# PVC Pro Channel Tracking Problem

## Bug Fix Guide

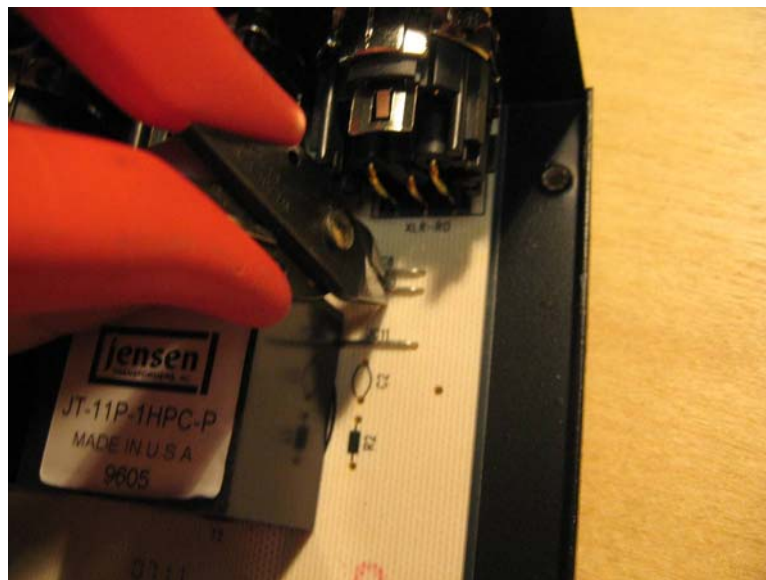
- c. Find the jumper connector JC10 from the board. It is located just behind the right output connector.

- d. Using your wire cutters, cut the jumper off.
